**COMMISSION OF ARCHITECTURAL REVIEW  
STAFF REPORT  
June 26, 2018, Meeting**

10. COA-036152-2018 (E. Pou)

**3629 East Broad Street  
Chimborazo Park Old and Historic District**

**Project Description:** Construct 2 new, 3-story single family dwellings.

3629 East Broad Street (1925 Sanborn Map)

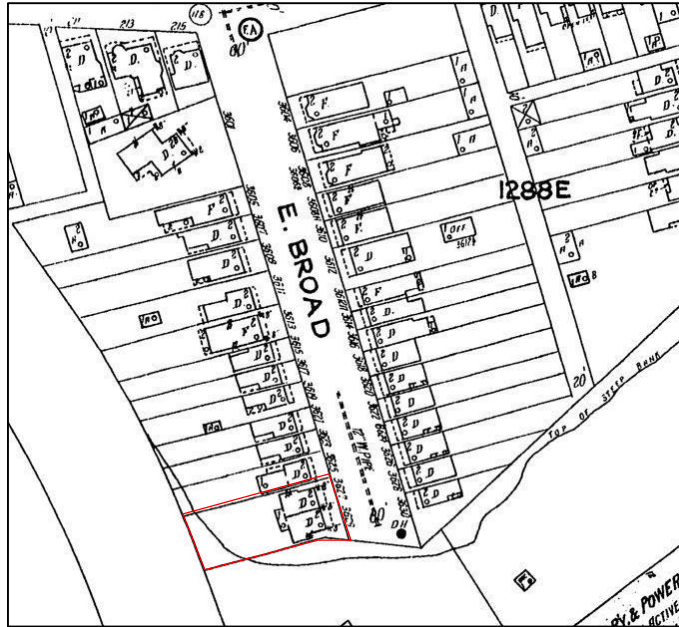
The front yard setback is shown as 15’ and the side yard set backs are shown to be 8’. The front yard setback is consistent with that of the adjacent home though staff has concerns with parking being located in the front yard setback as this is not a form found in the district. In addition, parking in a manner that is visible from a public street is prohibited by zoning. Staff recommends the parking area be relocated to the side or rear of the structure. The proposed side yard setback appears to be consistent with that of the adjacent property.

The historical pattern for the block is consistent with the front yard setback pattern of the adjacent structure. On the subject side of East Broad Street, the side yard setbacks vary.
